H11550

## DESCRIPTIVE REPORT

# Descriptive Report to Accompany Hydrographic Survey H11550

Project OPR-N395-RA-08  
Colvos Passage and Vicinity, Washington  
Southern Portion of Colvos Passage  
Scale 1:10,000  
April 2008  
**NOAA Ship RAINIER (s221)**  
Chief of Party: Commander Donald W. Haines, NOAA

Figure 6: Field sheets and BASE surfaces submitted with H11550.

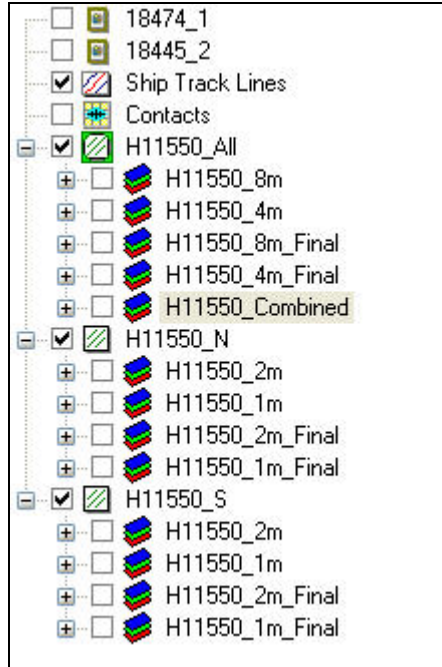
Many BASE surfaces were used in processing H11550. The submission Field Sheet and BASE Surface structure are shown in Figures 6 and 7.<sup>13</sup> Soundings and contours were generated in CARIS HIPS from the final combined BASE surface for field unit review purposes. They are included for reference only and are not intended as a deliverable.

- <sup>12</sup> Concur.
- <sup>13</sup> New fieldsheet and surfaces were created during office review. The 4-meter combined surface was used for compilation purposes.

Figure 8: 5.1-fathom sounding over charted 6.3 fathom sounding (chart 18445\_2).

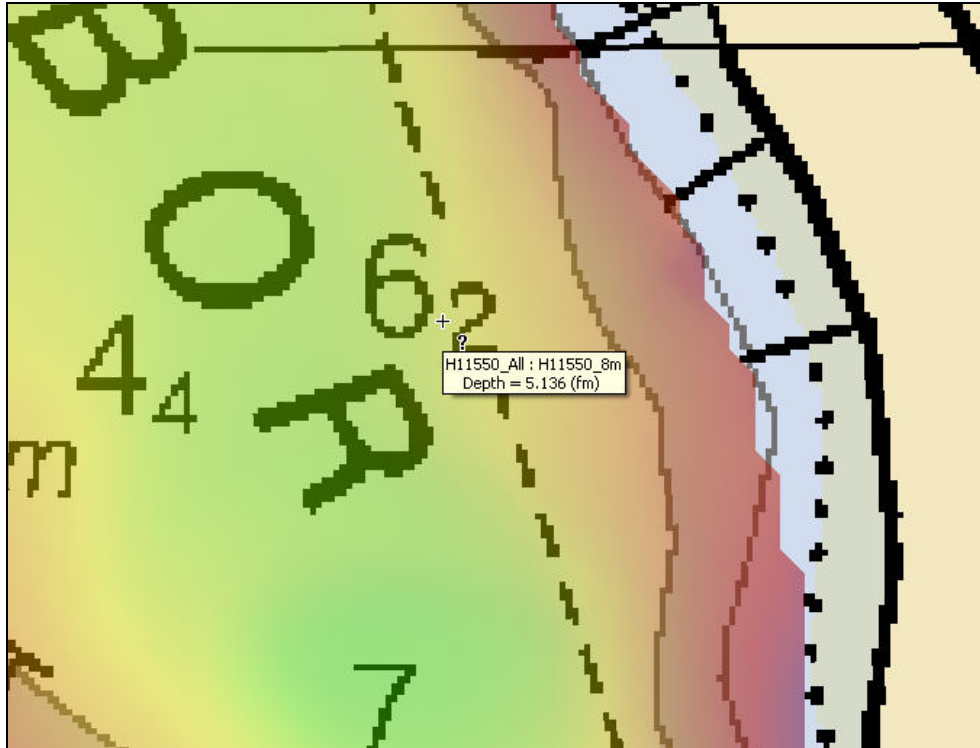
Bathymetry within the main channel of southern Colvos Passage generally agreed within 1 fathom and never differed more than 2-fathoms from charted depths.<sup>17</sup> Bathymetry in Gig Harbor agreed within 0.5 fathom with the following exception of a shoaler sounding shown in Figure 8<sup>18</sup>:

The Hydrographer recommends that survey soundings supersede all prior survey and charted depths in the common area.<sup>19</sup>

- <sup>14</sup> Concur.
- <sup>15</sup> Report is appended to this document.
- <sup>16</sup> Concur.
- <sup>17</sup> Concur.
- <sup>18</sup> Concur.
- <sup>19</sup> Concur.

Figure 9: Sewer pipeline in 2-meter resolution bathymetry overlaid on Chart 18445\_2.

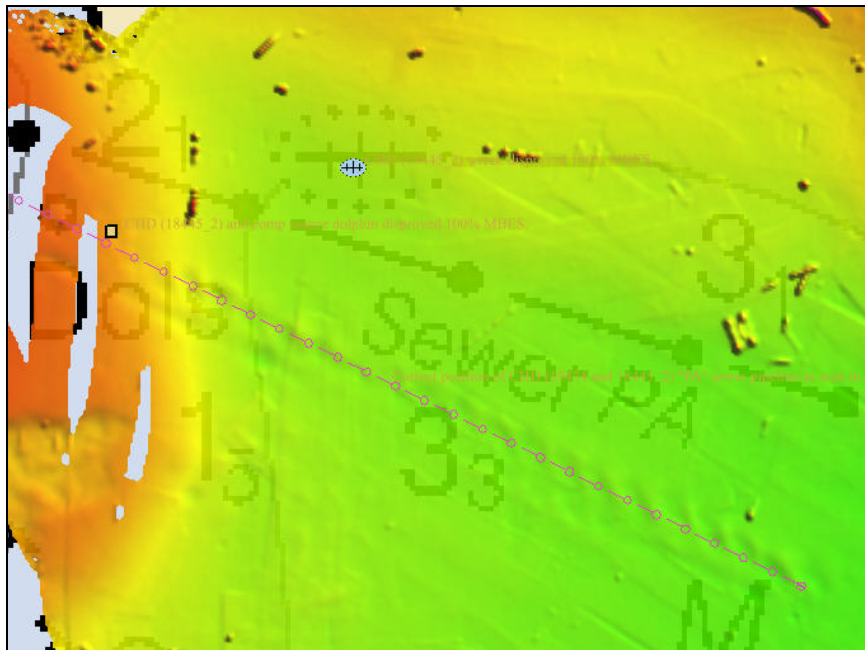
- Gig Harbor Sewer Pipeline: The hydrographer recommends modifying the sewer pipeline area on charts 18474 and 18445\_2 to follow the path of the sewer seen in H11550 bathymetry and removing the charted “PA” associated with this item. A digitized pipeline was added by the hydrographer in the H11550 Notebook session (H11550\_NTBK) and was properly attributed as a new feature. See Figure 9 below.<sup>28</sup>

- <sup>26</sup> Use the latest ATONIS listing.
- <sup>27</sup> Concur.
- <sup>28</sup> Concur. Compiler used a \$LINES feature to identify the pipeline.
- <sup>29</sup> Concur.

Figure 12: 2-meter resolution bathymetry over Tahlequah cable area on chart 18474.

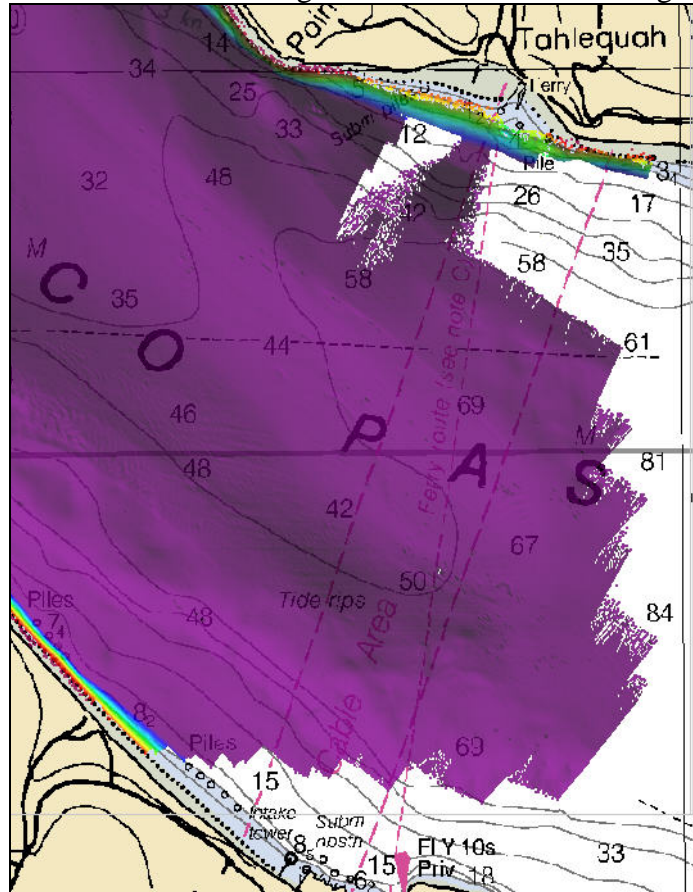
- Tahlequah: Partial coverage of cable area. Nothing seen in the bathymetry. The hydrographer recommends retaining charted cable area. See Figure 12 below.<sup>31</sup>

- <sup>30</sup> Concur. Compiler used a \$AREAS feature to represent the new cable area.
- <sup>31</sup> Concur.
- <sup>32</sup> Concur.
- <sup>33</sup> Retain all bottom samples as charted.

Figure 1.1.1

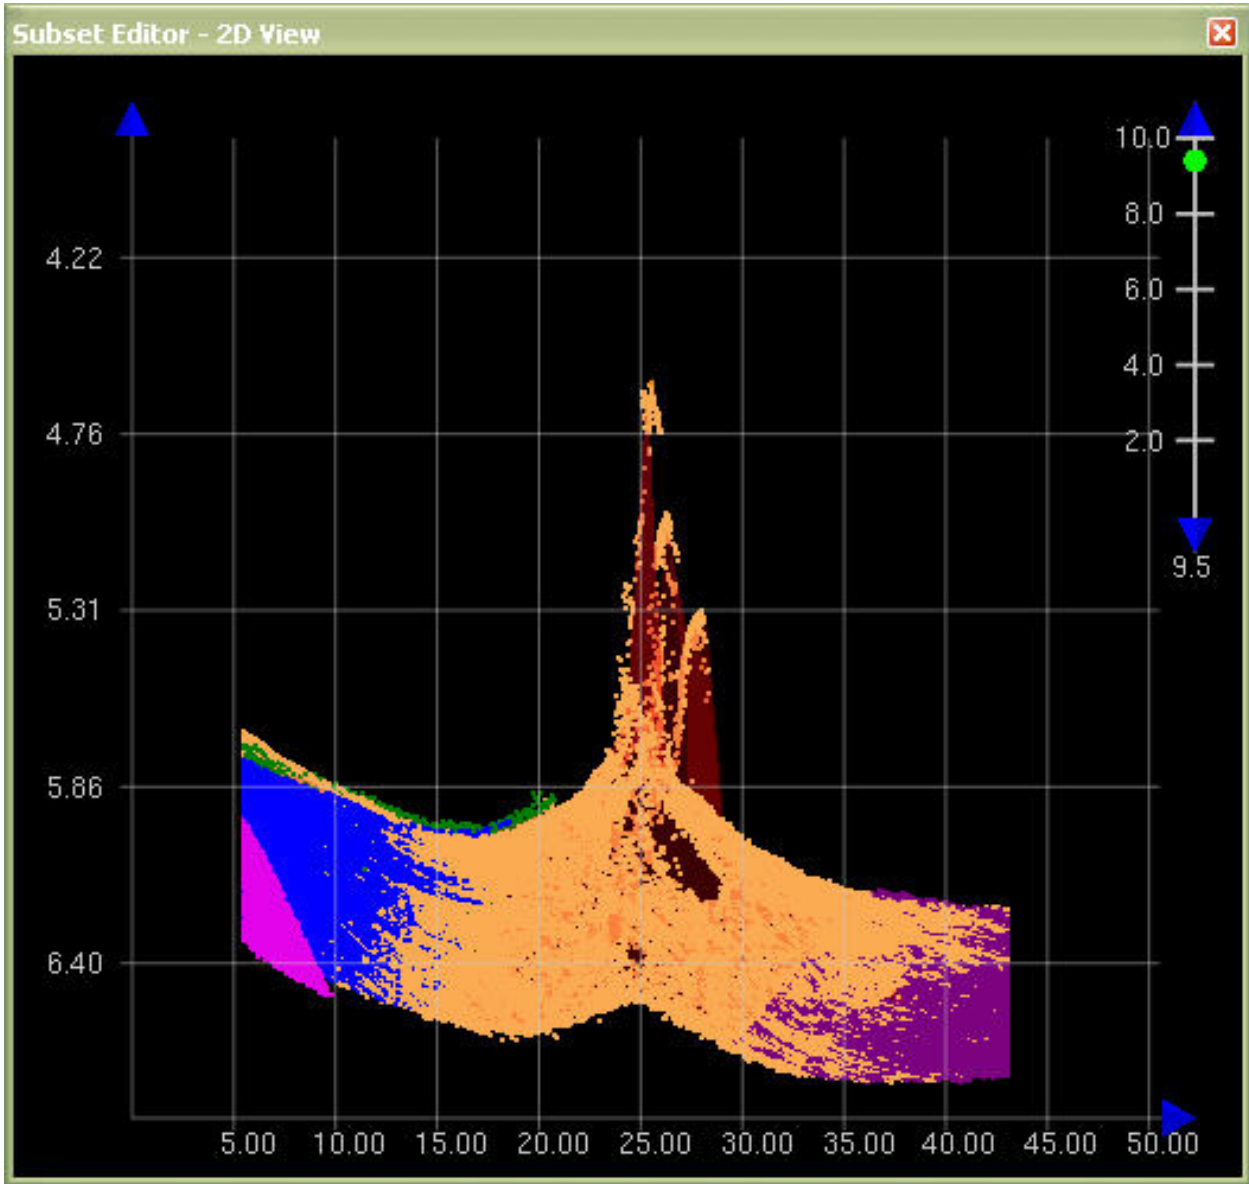
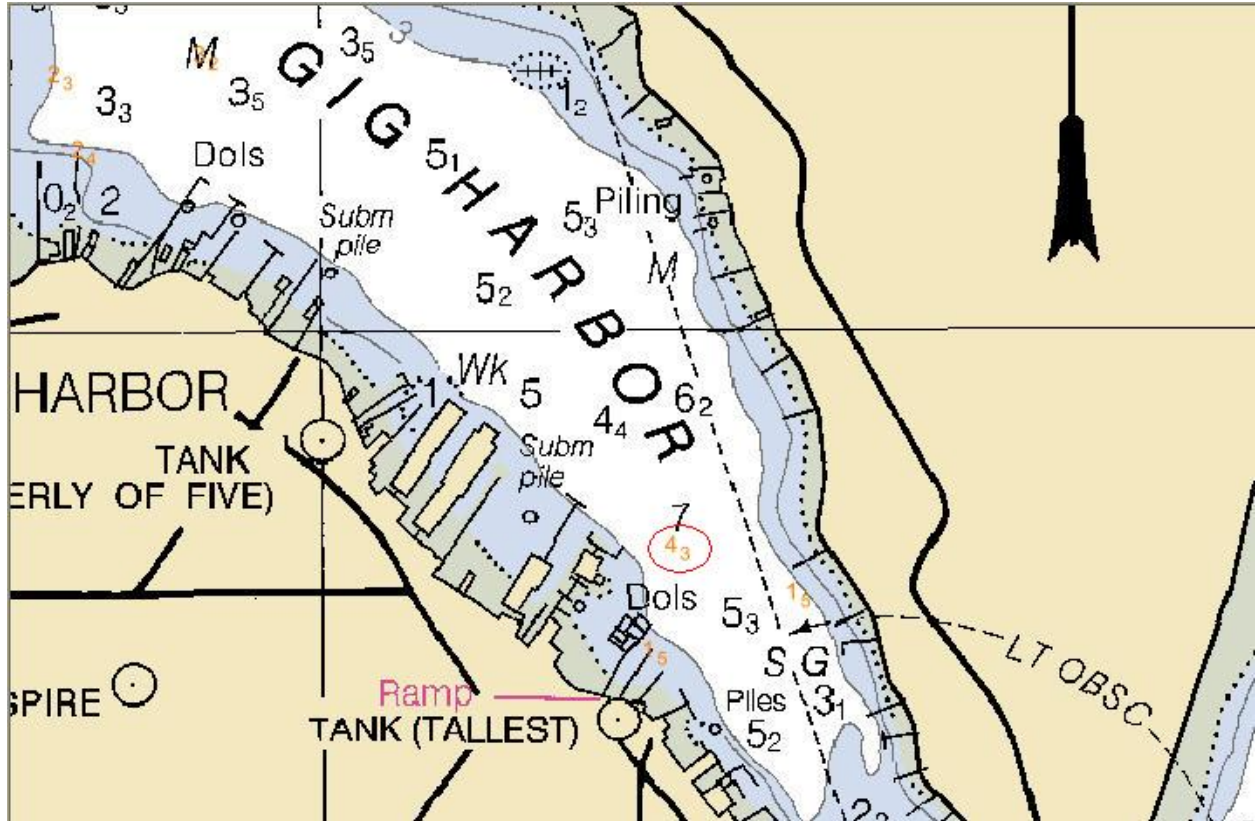
Office noted DTON, shoalest sounding designated in CARIS from MBES data.

Chart new shoal sounding

Chart new shoal as sounding.
